Certificate of Appropriateness

Property	2431 N. GRANT BL.	North Grant Boulevard Historic District
Description of work	Install new all-wood windows on rear addition and patch stucco to match surrounding surfaces. Install new all-wood bathroom windows on south elevation and patch stucco to match surrounding surfaces. Stucco returns on Bathroom windows to match the original windows on the house. Flat wood trim, 4 inches wide (approximate) on new windows in addition. Wood railing on walk-out deck of rear addition will be changed at a later date according to the drawings included in this COA.	
Date issued	4/7/2014	PTS ID 92809 COA, selected new windows

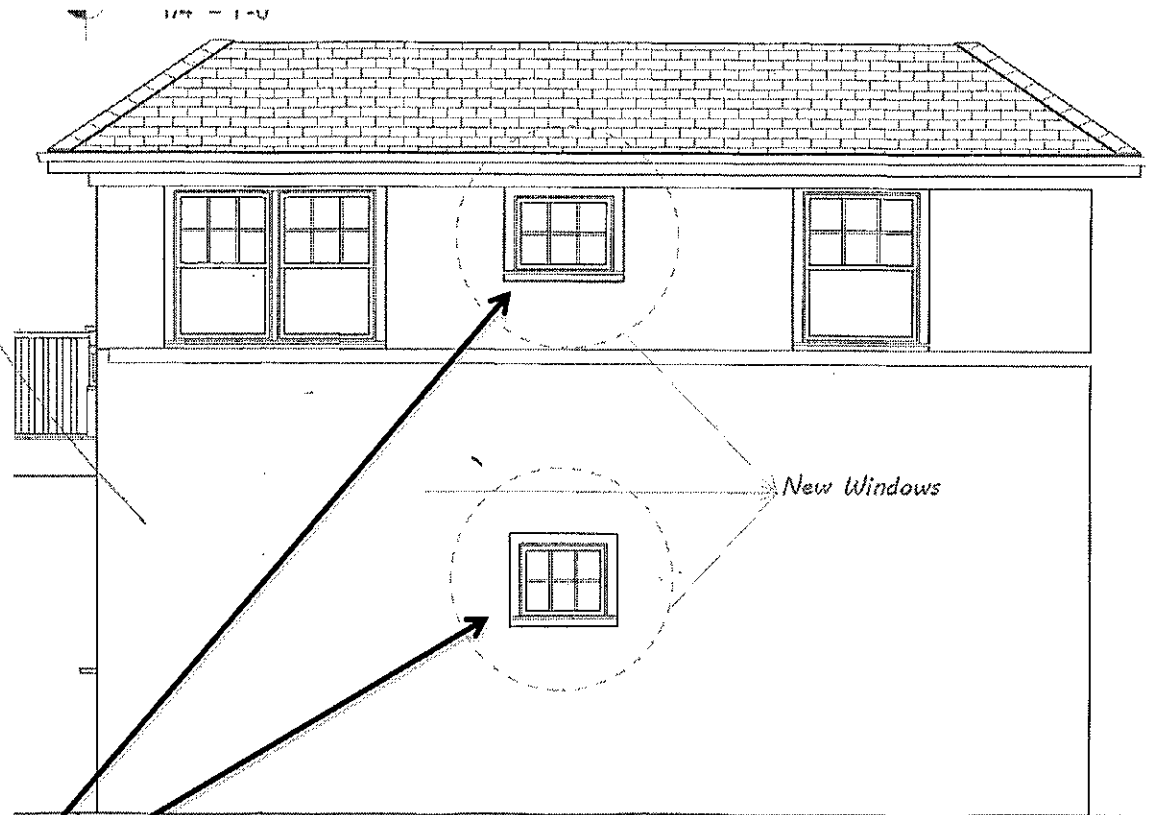
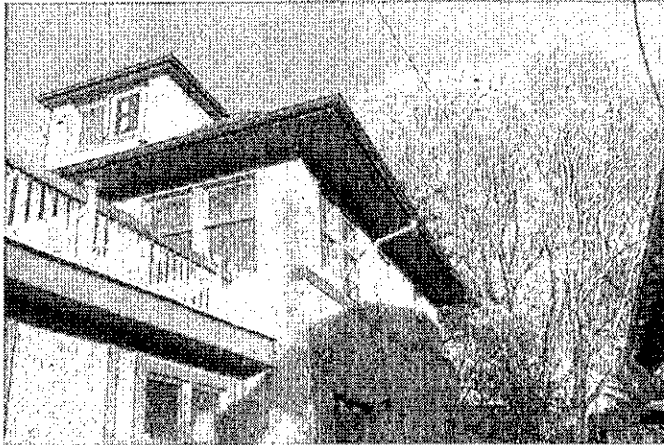
Window to be added to
2nd floor bath. To match top part
of existing wood window

New south elevatino of rear addition. This may be changed to a taller bay of three small windows as indicated in notes on drawing.

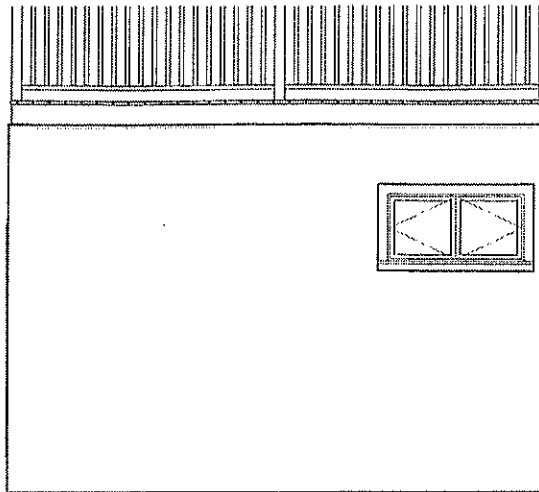
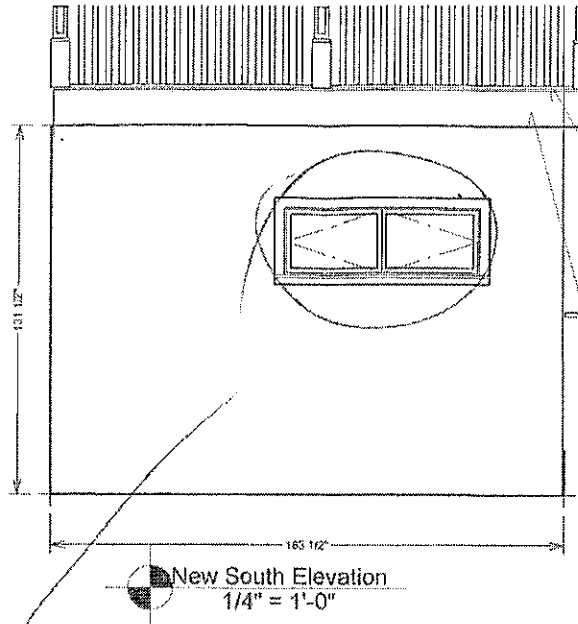
**New wood windows with wood muntins
permanenently fixed in placce to be installed on
south elevation. Returns to match the windows in
the original part of the house.**
